# CONVAIR

## COMMERCIAL CHANGE PROPOSAL

SPEC NO.: ZD- 22-003

MODEL: 22-2 (Convair "880")

- Enclosures: (A) One copy of Figure 1-1, GENERAL ARRANGEMENT (for information only, figure in Specification will be revised to show leading edge slats on acceptance of this change)
- (B) One copy of Convair Drawing SD-58-03147 - WING L. E. SLAT (for information only)

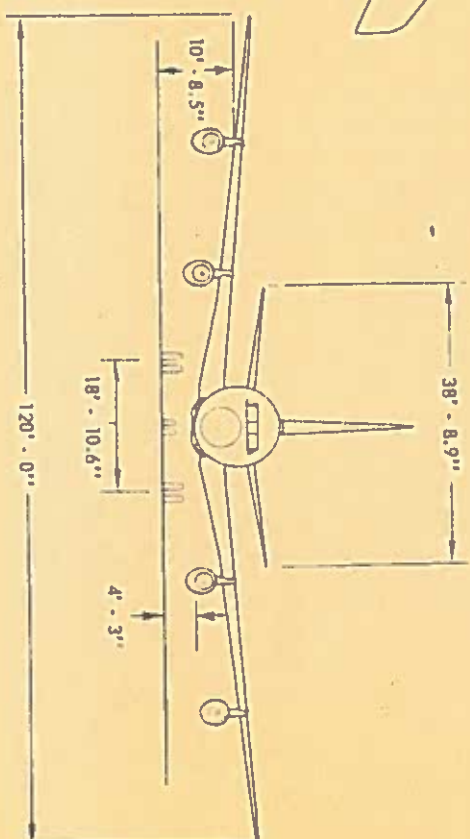
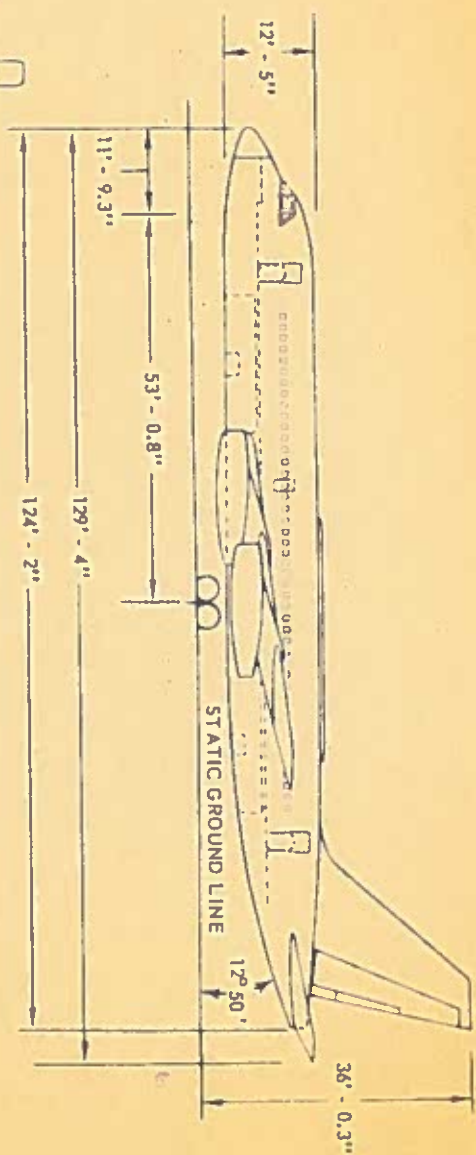
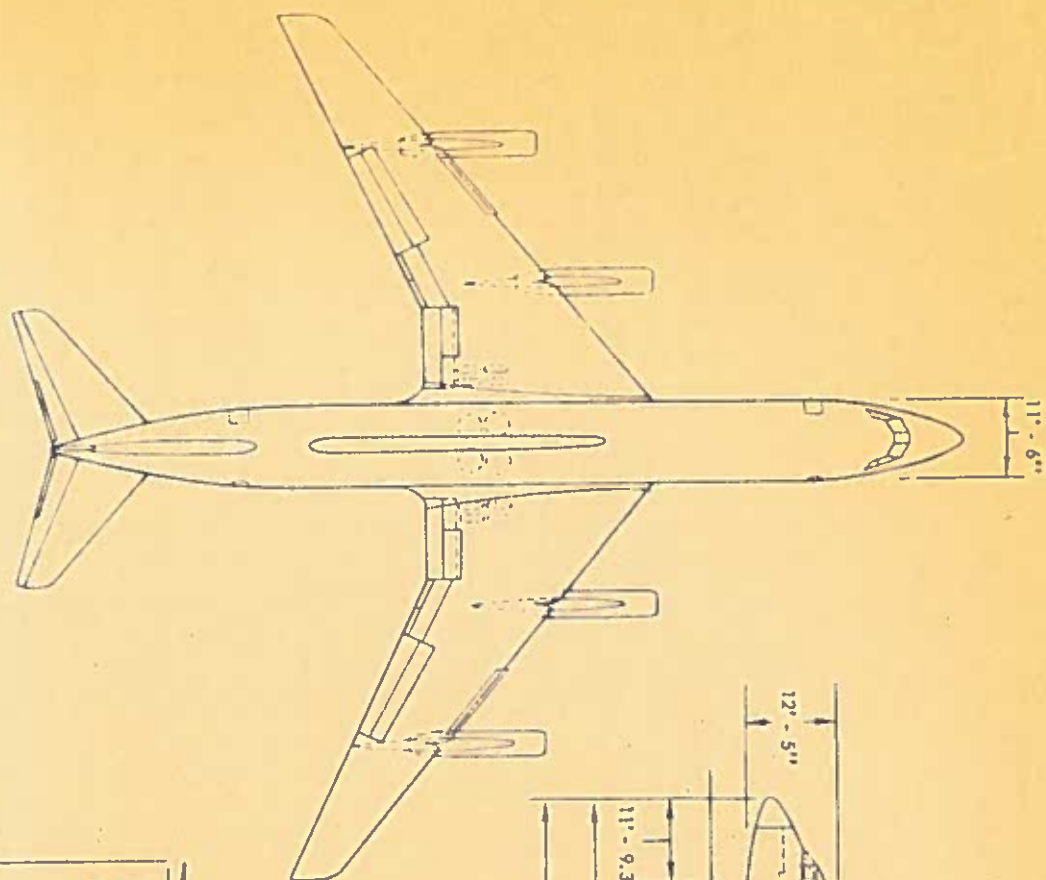
Page A-3, APPENDIX I-C, ELECTRICAL EQUIPMENT:

Add the following item to the Description List:

"2 Gear Boxes, Leading Edge Slat Actuating (with two electric motors each)"

Page 62A, Figure 3.14-1 PILOT'S AND COPILOT'S INSTR. PANELS:  
Page 62B, Figure 3.14-2 PILOT AND COPILOT CONSOLE:

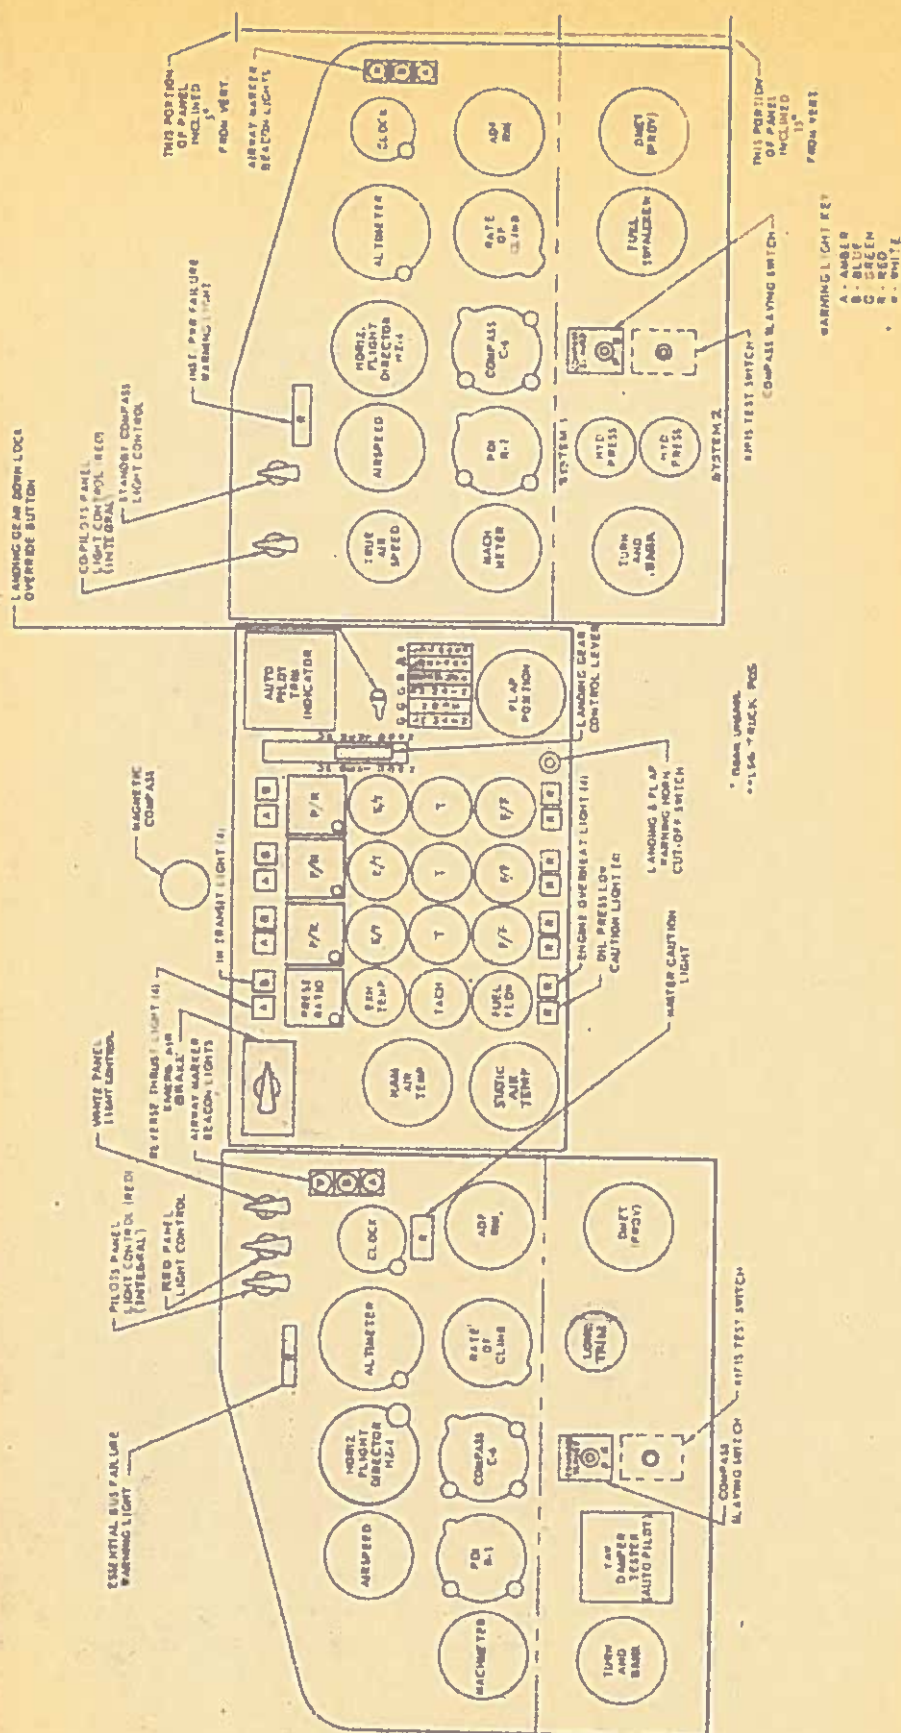
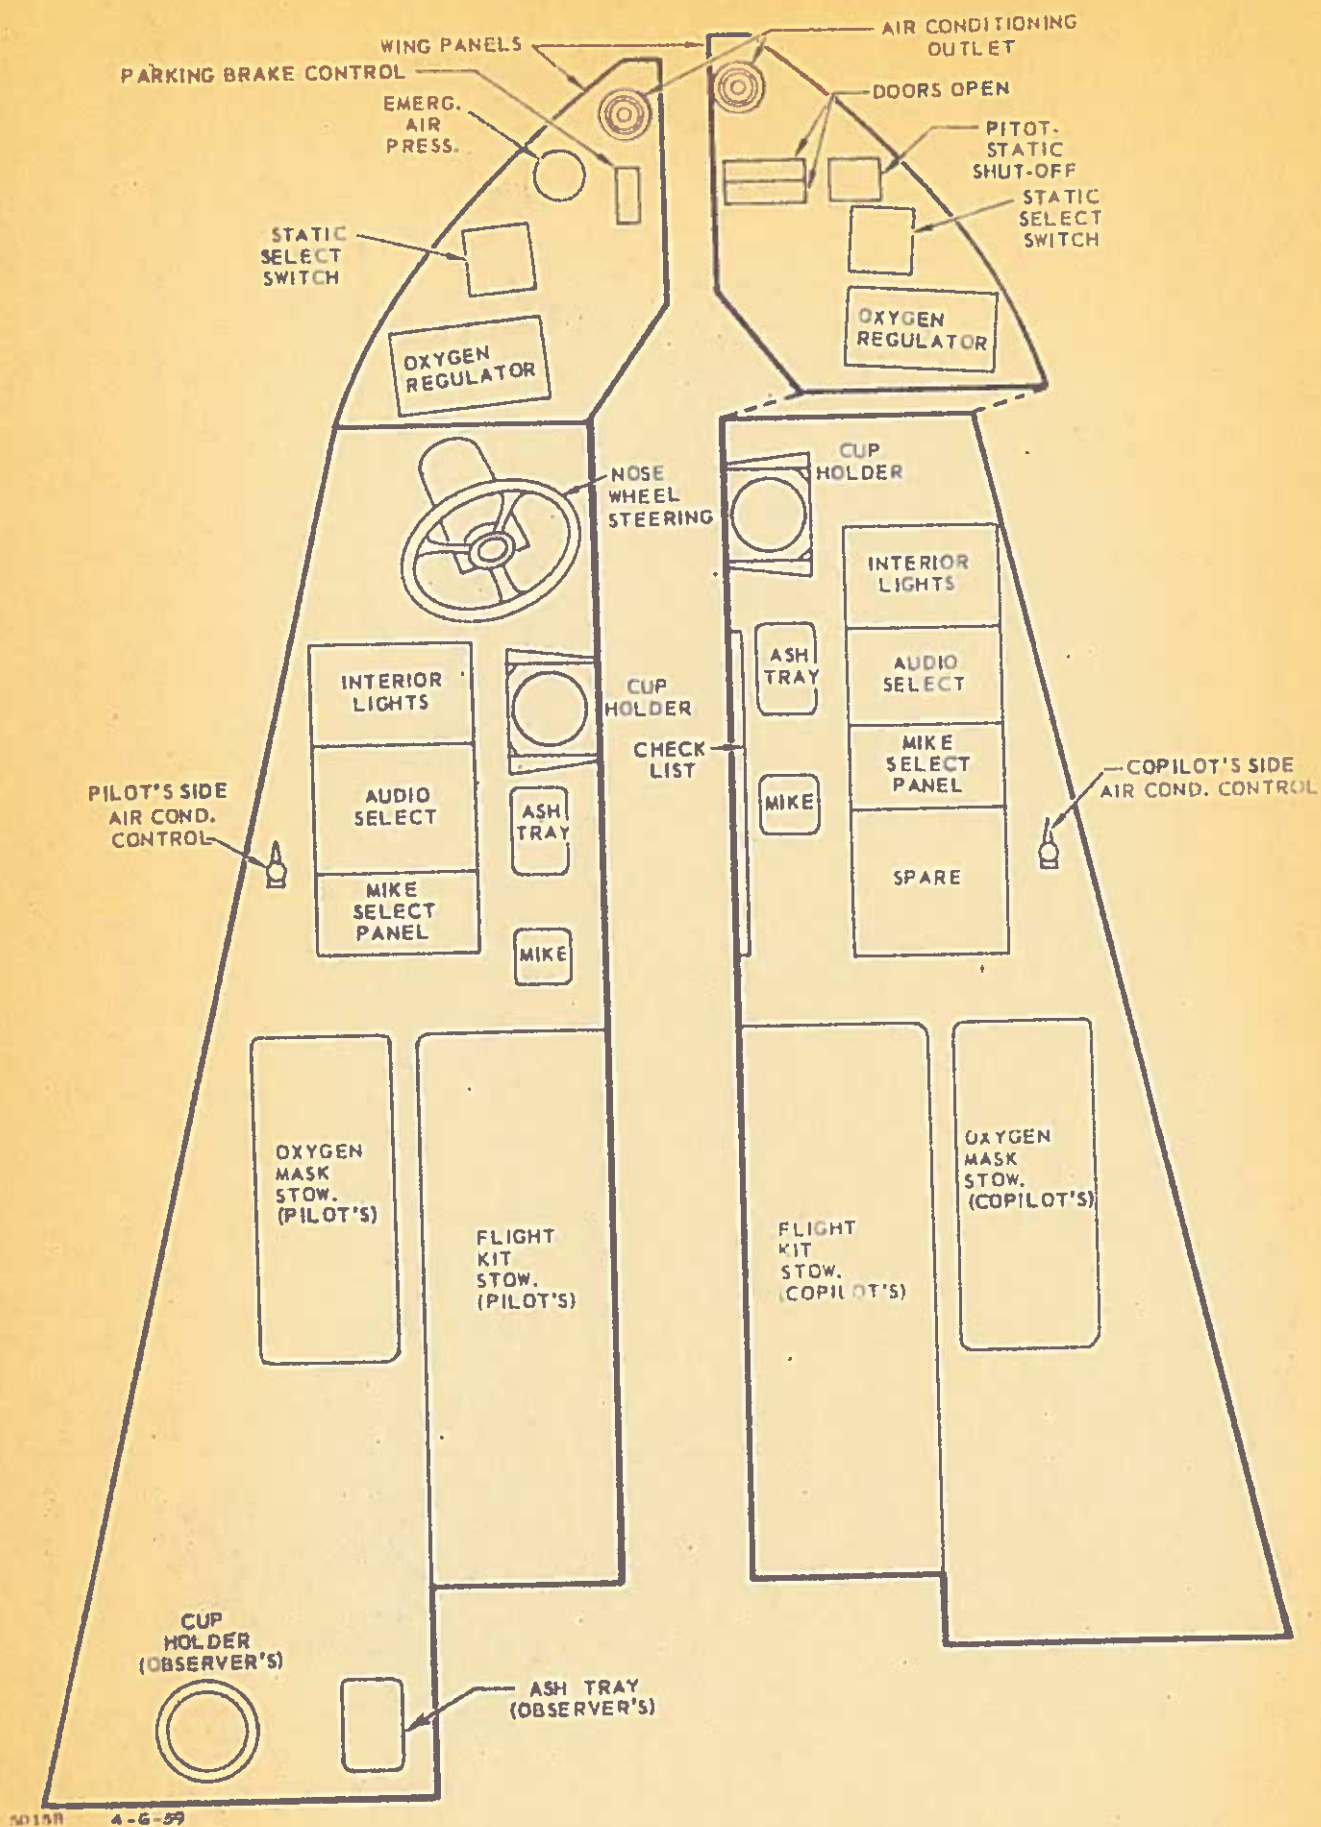
"This proposal has no effect on the specification language but relocates the Emergency Air Brake control handle from the pilot's console to the pilot's and copilot's instrument panel and rearranges various other instruments as shown in the attached revised illustrations."

Figure 3.19-4

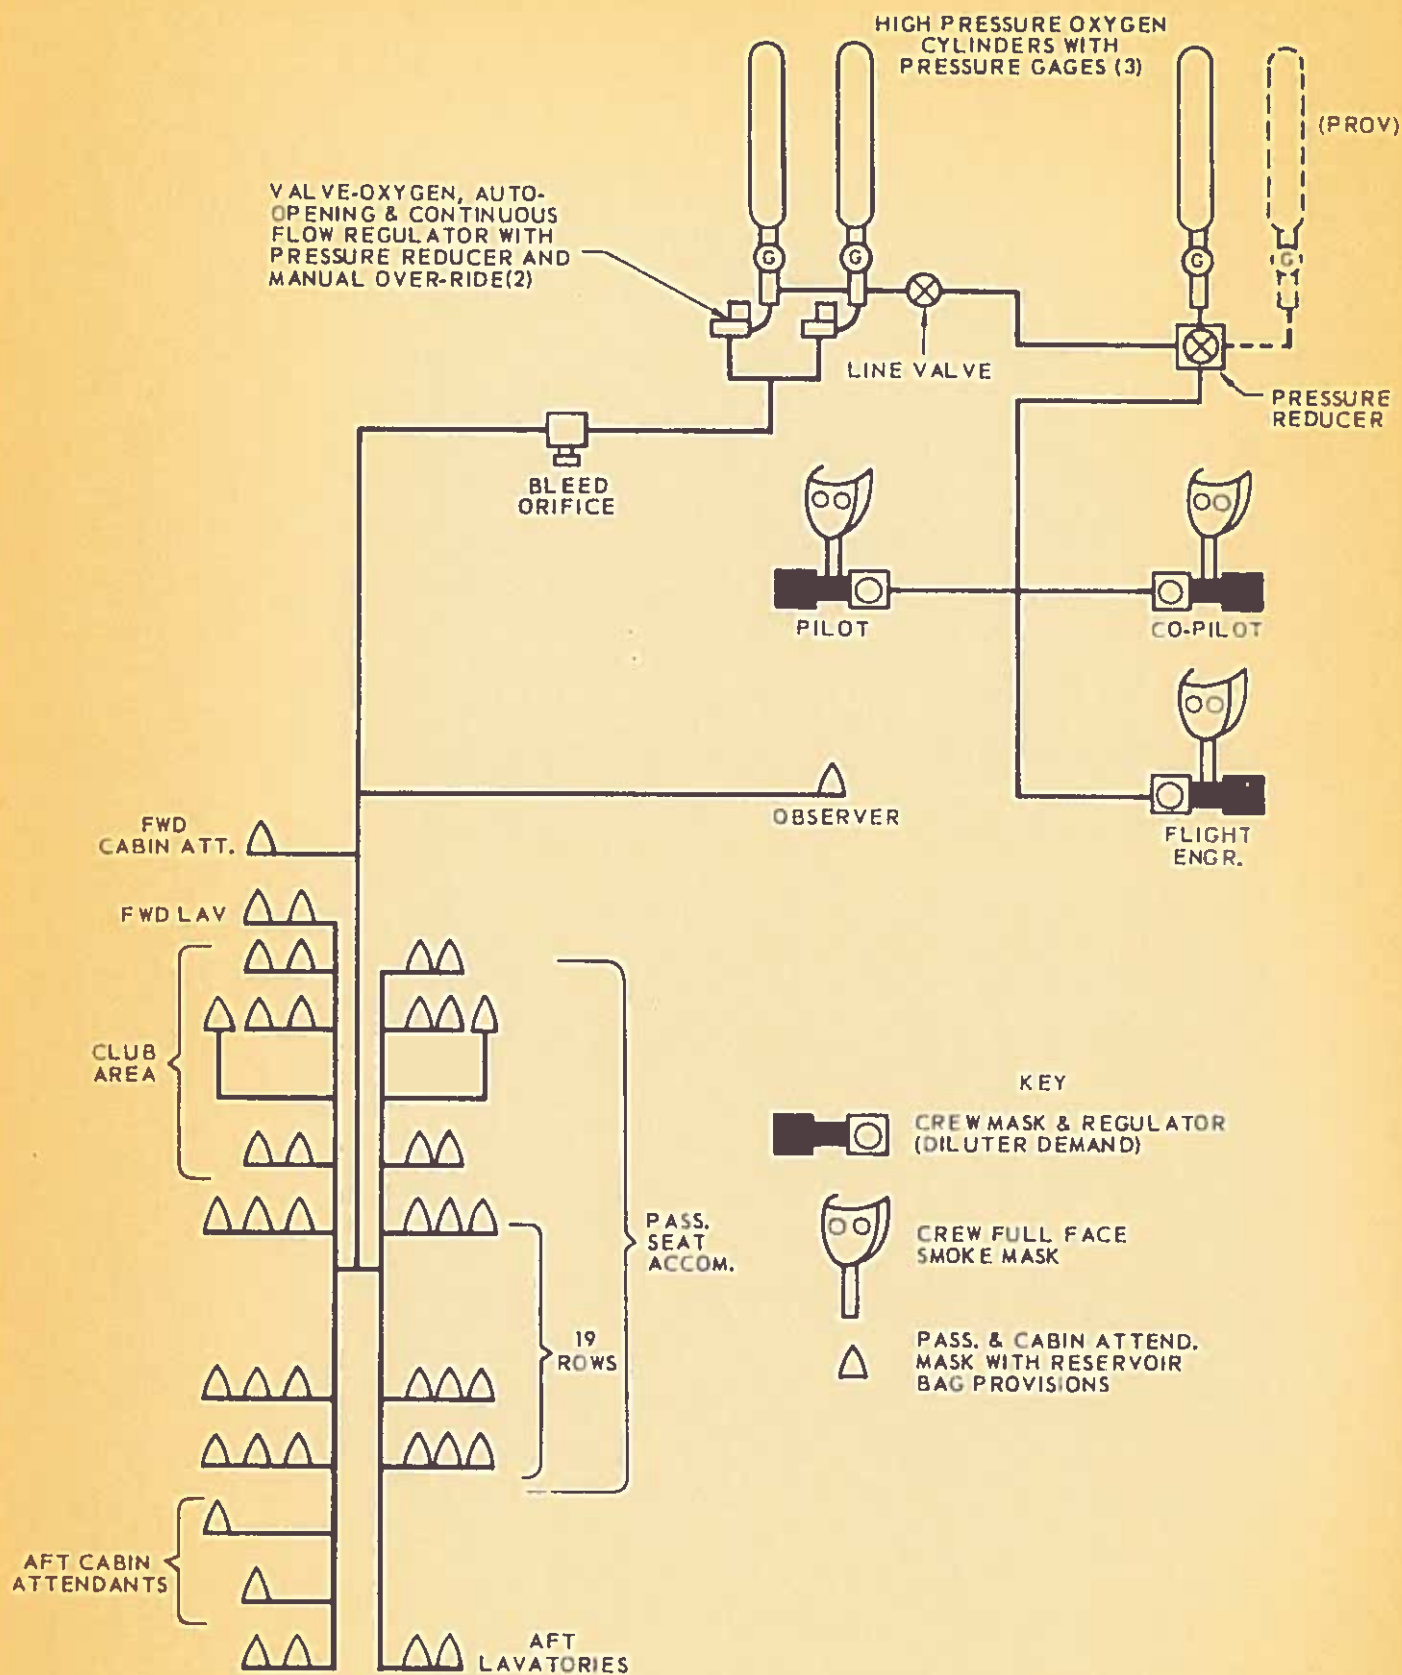
"Provisions for one additional mask shall be made for each seat  
row in the main cabin area (three masks for each of the 19 rows  
on both sides of the airplane) to provide for emergency oxygen for  
children in arms. The oxygen outlet system for the club area shall  
be as shown on Figure 3.19-4".

Figure: 3.19-4 - GASEOUS OXYGEN SYSTEM:

Above figure will be replaced in the specification with Enclosure (A)  
on Customer approval of this CCP.

Figure 3.19-3

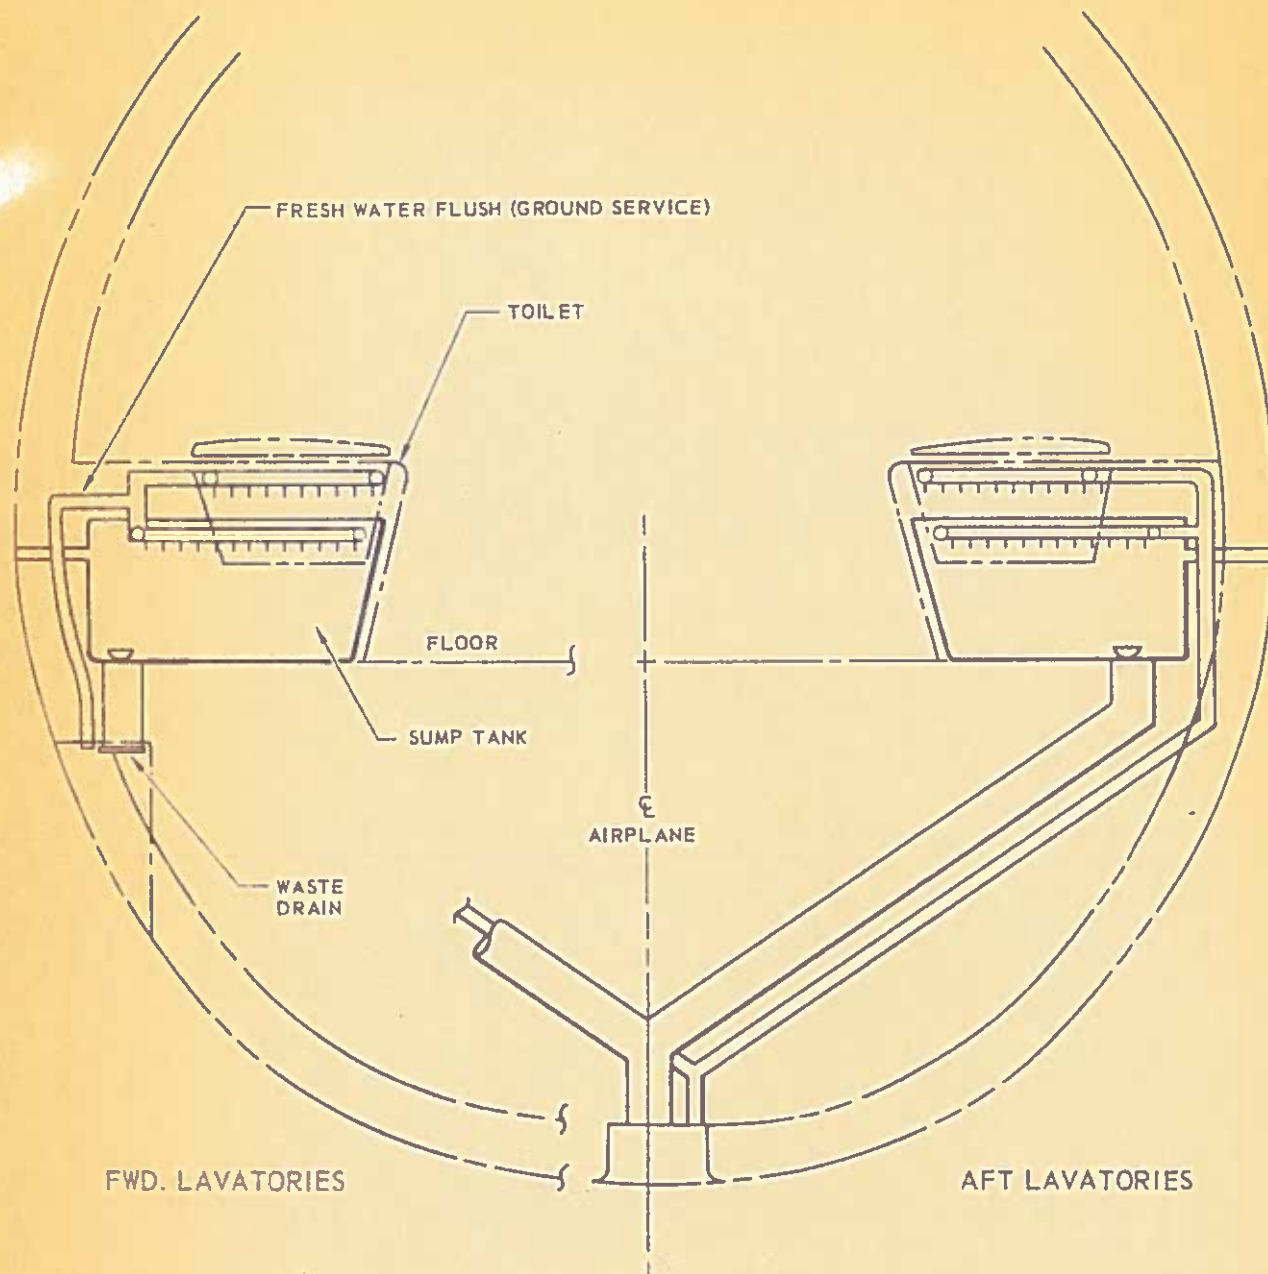
Reason for Change: To provide an up to date Lavatory Toilet Water System Schematic.

Delete FIGURE 3.19-3 - LAVATORY TOILET WATER SYSTEM SCHEMATIC  
from Specification and replace with Enclosure (A).

Enclosure: (A) One copy Page 115f - FIGURE 3.19-3 - LAVATORY TOILET  
WATER SYSTEM SCHEMATIC
